CITY OF ALBUQUERQUE

RE: Precision Eye Center
7521 Alameda Blvd. NE
Grading & Drainage Plans
Engineer's Stamp Date: 02/28/23
Hydrology File: C19D070

Based upon the information provided in your submittal received 03/02/2023, the Grading & Drainage Plans **are not** approved for Building Permit, Grading Permit and SO19 Permit. The following comments need to be addressed for approval of the above referenced project:

C103

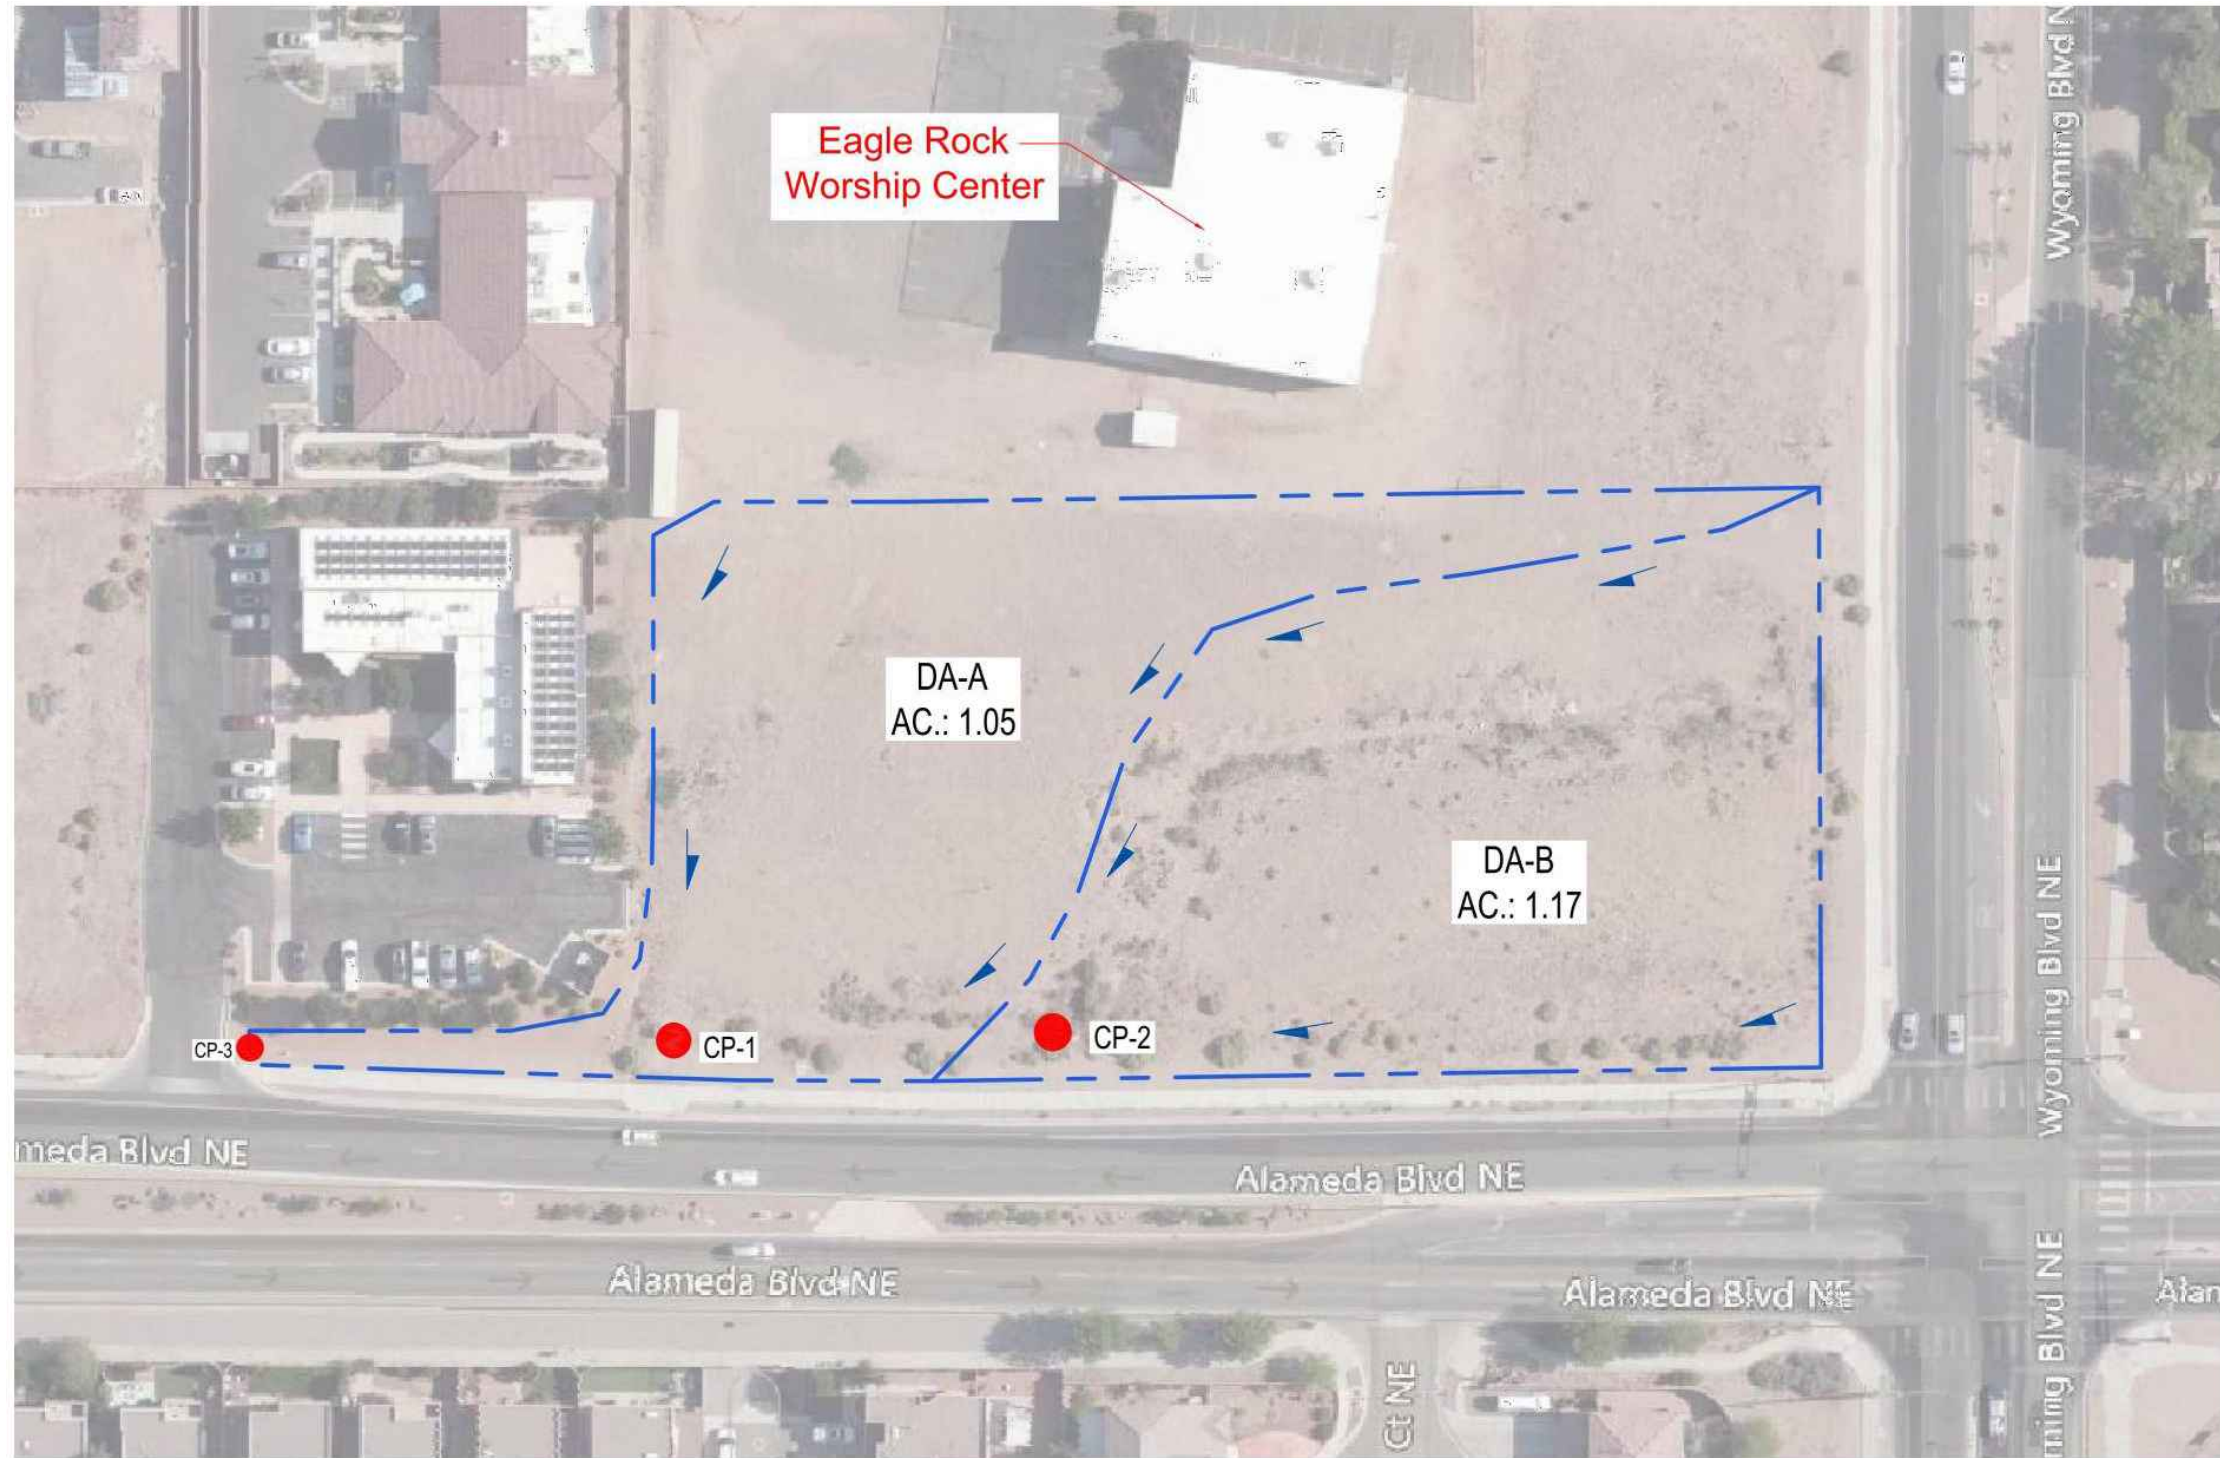
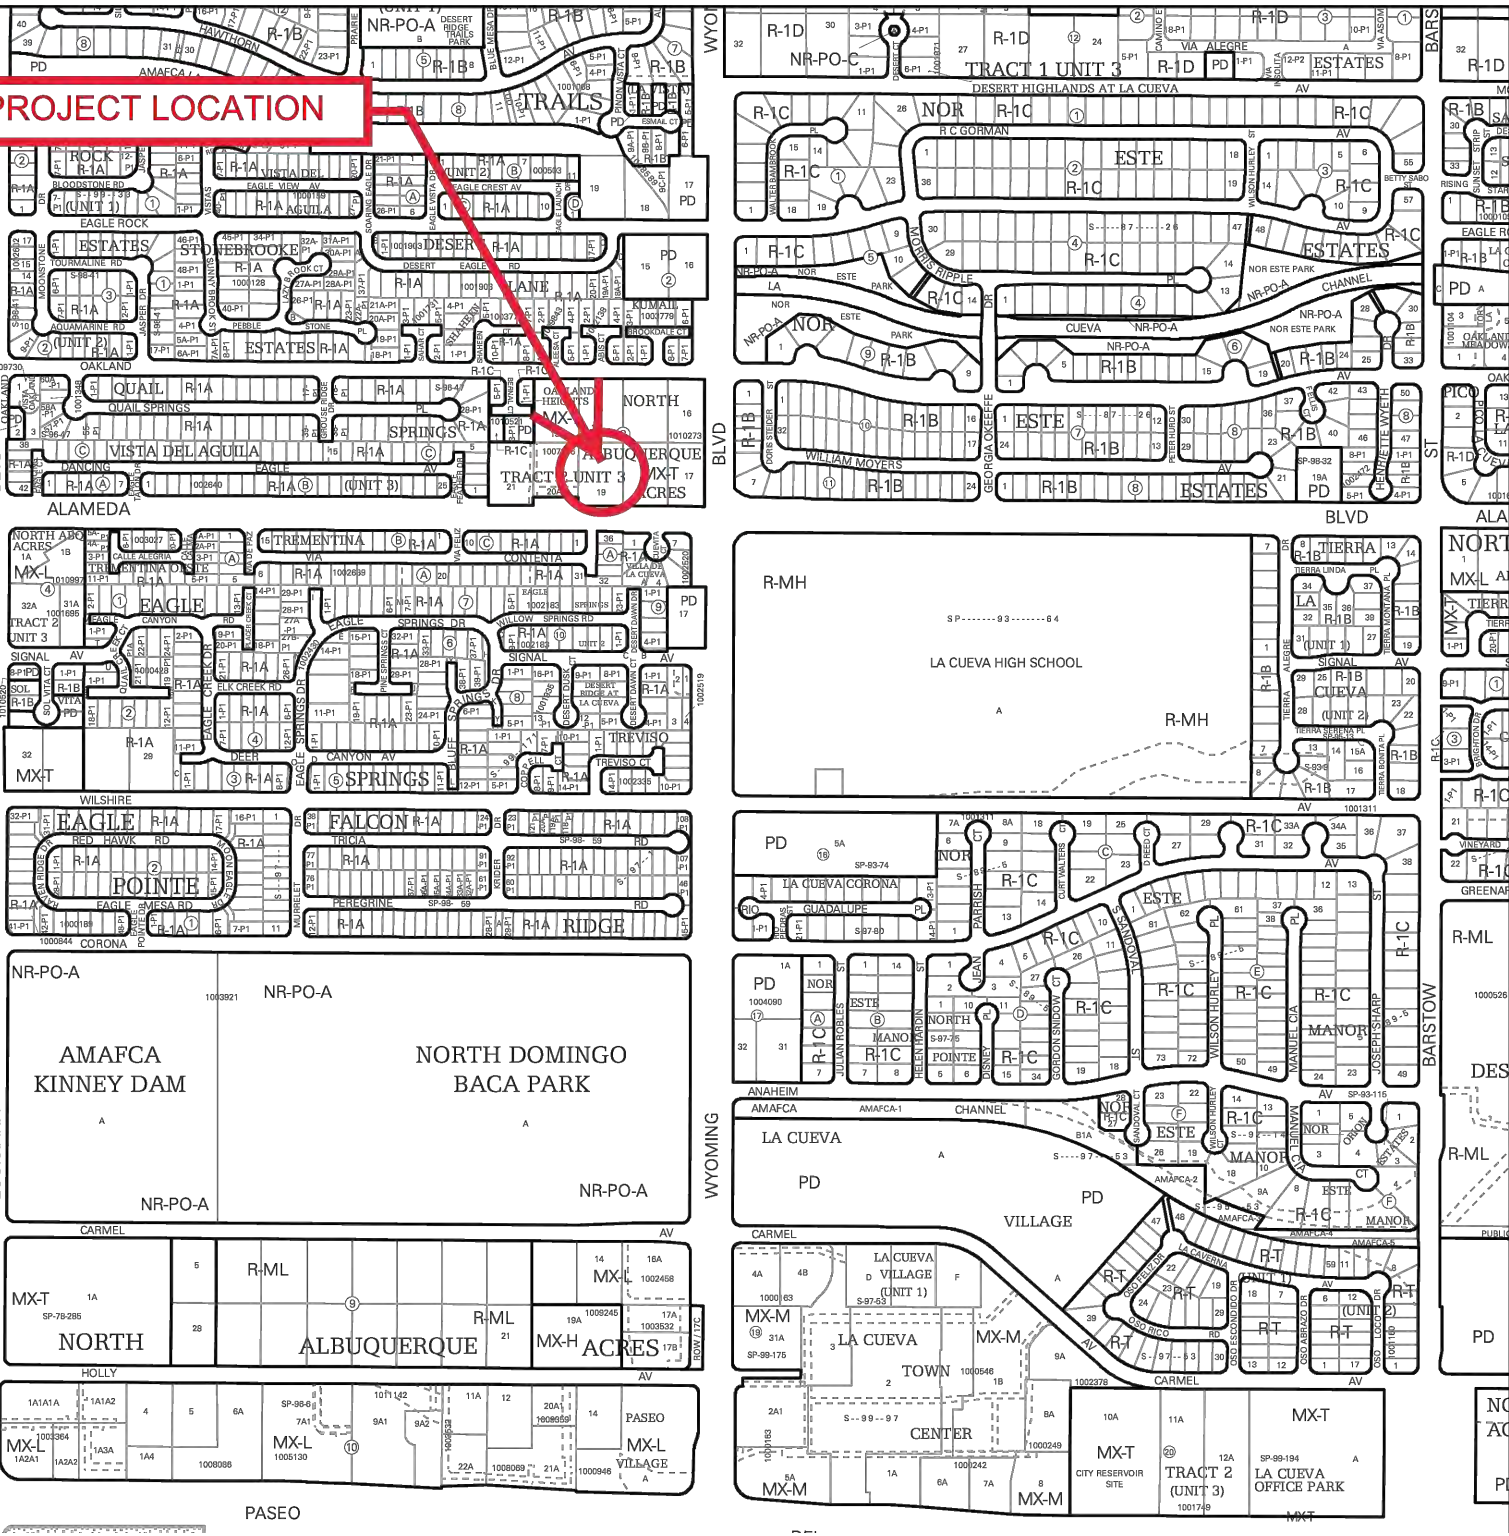
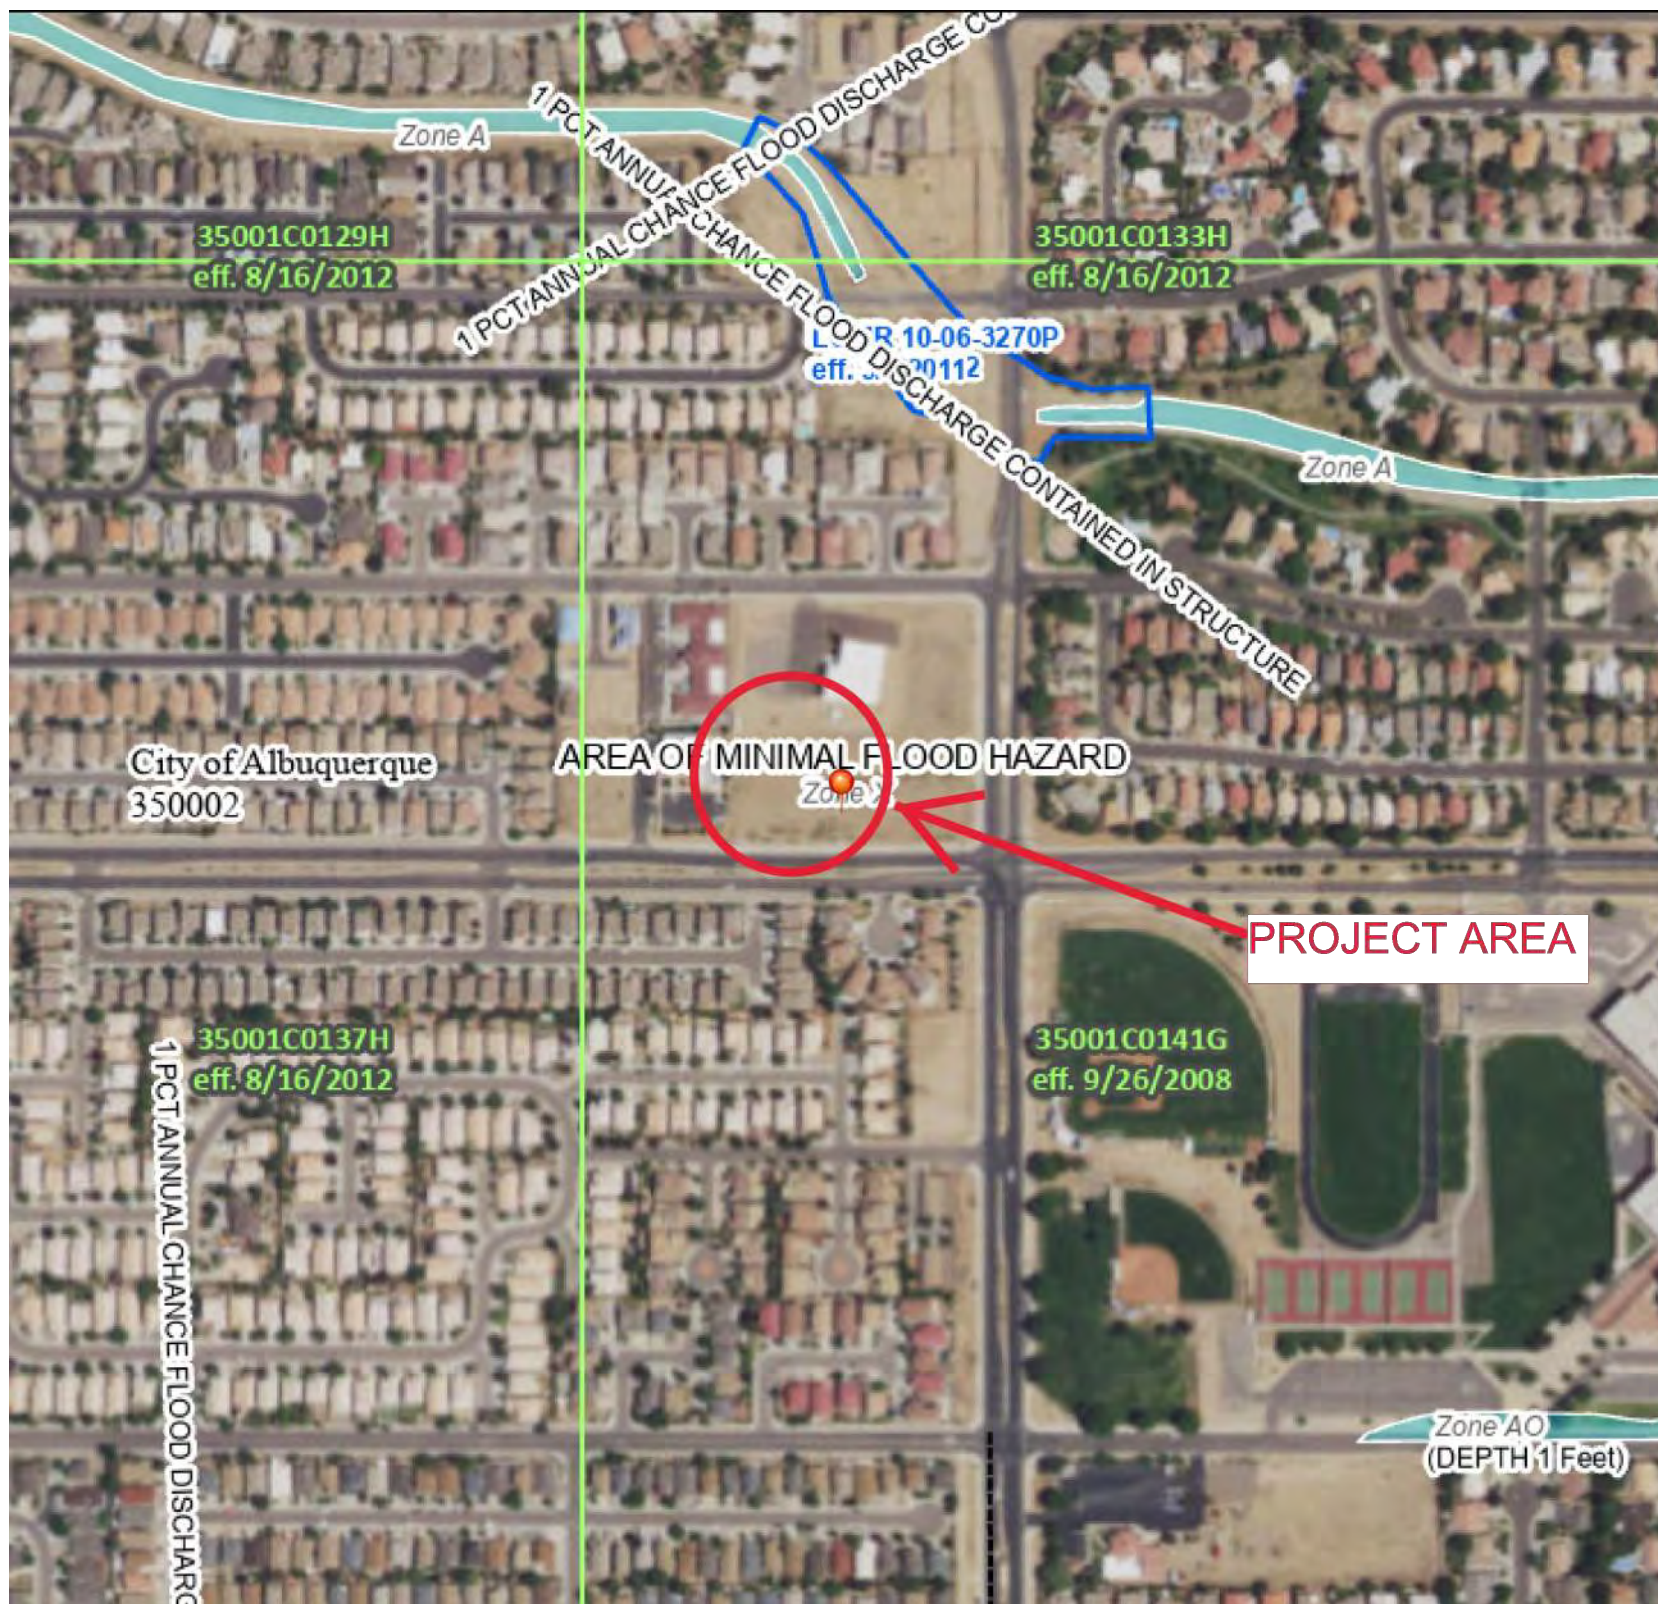
- On Sheet 103, under the Existing Conditions. Please state, "Project is with North Albuquerque Acres Master Drainage Plan by Resource Technology, Inc. October 1998 which this site has an allowable discharge rate of 3.60 cfs/ac".

- On Sheet 103, the Stormwater Quality Pond volume is incorrect. Per DPM Article 6-12 Stormwater Quality and Low-Impact Development for the sizing calculations, 0.42 inches for new development sites and 0.26 inches for redevelopment sites. This site is a new development and not a redevelopment.

8. On Sheet 103, please provide the weir calculations, per DPM Article 6-16(A), for the curb cuts and sidewalk culverts. A coefficient of 2.7 is typically used for the weir equation $Q = CLH^{2/3}$.
9. On Sheet 103, please provide a cross section of the SWQ pond with the bottom of pond elevation, top of pond elevation, and SWQ water surface elevation.
10. On Sheet 102, please provide the Benchmark information (location, description and elevation) for the survey contour information provided.
11. On Sheet 102, please provide the SO-19 Standard Notes, latest version.
